U.S. NUCLEAR REGULATORY COMMISSION  
REGION I

Report No. 50-219/88-24

Facility Name: Oyster Creek Nuclear Generating Station

Inspection Summary: Inspection 50-219/88-24 on July 15, 1988 and  
July 18 through August 12, 1988

FIGURE 5.4-4A

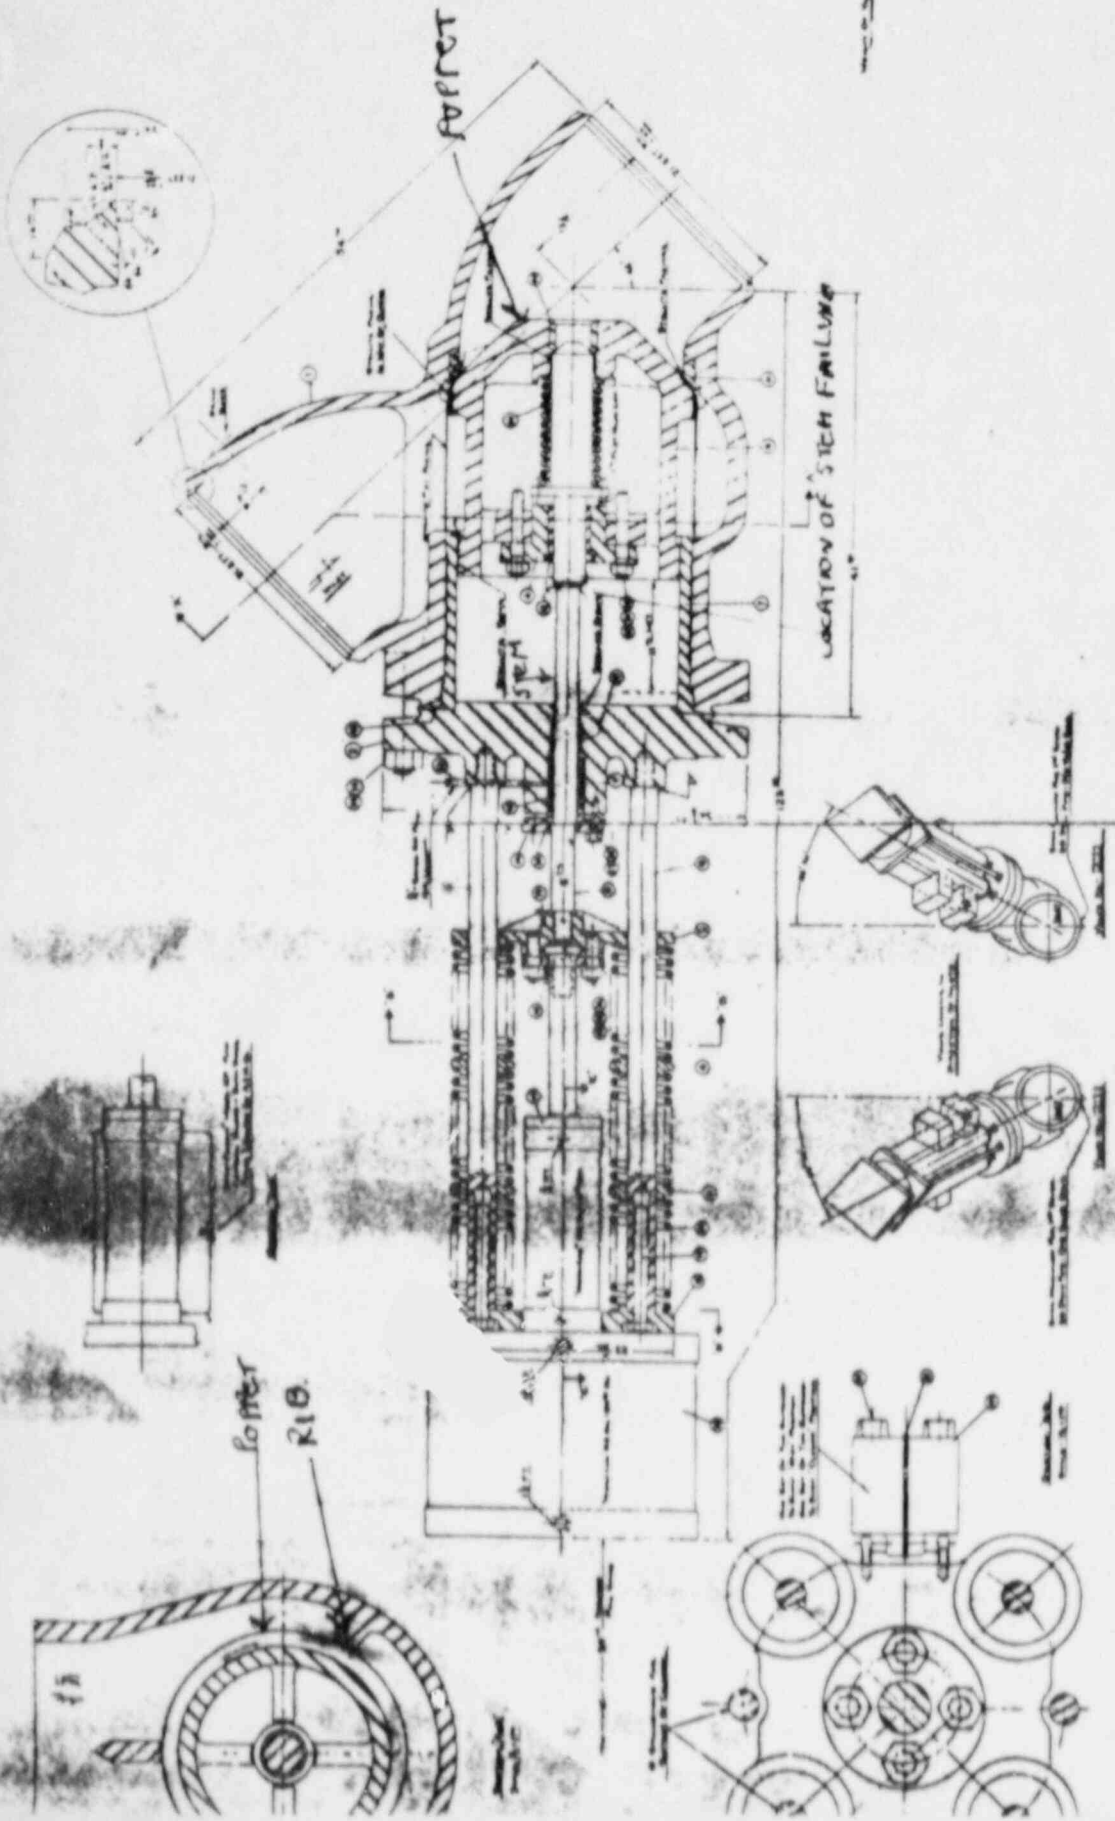
The Main Steam Isolation Valves, manufactured by Atwood and Morrill Company, are 24-inch angled globe valves having a "Y" pattern body (See Figure 1). The MSIV contains an internal pilot valve. The end of the valve stem seats in the pilot valve seat which is located in the center of the main poppet. The pilot equalizes the pressure across the main poppet prior to lifting the main poppet off its seat. The first one inch of stem travel opens the pilot valve and engages the main poppet. The next 11" of stem travel lifts the main poppet. The full stem travel from full closed to full open is twelve inches.

In the backseated position the valve stem remains under tension. When backseated the main poppet is laterally positioned at the top and bottom. At the top the poppet contacts a stellite faced valve liner which protects the valve body from damage. At the bottom, three stellite faced guide ribs (part of the valve body) contact pads on the main poppet. When looking down into the valve body, one of the three guide ribs is positioned in the inlet flow in the lower portion of the valve body. The main poppet rests on this guide rib and it appears to be more susceptible to damage.

On July 15, 1988, the inspector visually examined the failed 58" long stem after its removal from valve NS03A. The failure occurred in the stress relief groove in the transition area between the 2.245" diameter and 2.725" diameter sections. The specific root profile is to be established by GE in their failure analysis. The fracture faces exhibited smooth, rose colored oxidized surfaces in approximately 75% of the area and a rough, appearing type of fracture in the remaining 25%, the latter apparently representing the ductile failure of last portion of the stem. No evidence of gross plastic deformation ("necking down") at the fracture ends was observed. The lack of plastic deformation coupled with the resultant fracture pattern is generally indicative of high cycle fatigue as being the mechanism of failure. It is noted that no visual evidence of corrosion (pitting or wastage) or surface abuse (e.g. gouges) was observed by the inspector in the vicinity of the failure. Evidence of surface abrasion was observed for about 2" along the length of the stem at the pilot end of the stem which may have occurred during operation, or during installation or removal. The licensee also reports excessive wear

between the valve poppet pad and the rib guide. The extent of the wear was approximately 4 inches along the rib starting at the top of the rib.

The short term corrective action to repair MSIV NS03A is to replace the stem and return the guide ribs to the manufacturer's specifications. The valve will be local leak rate tested prior to restart. NS-04A will be repaired by replacing the valve stem and repairing the guide ribs. The valve will be reassembled with proper poppet alignment. The valve will be LLRT prior to startup.
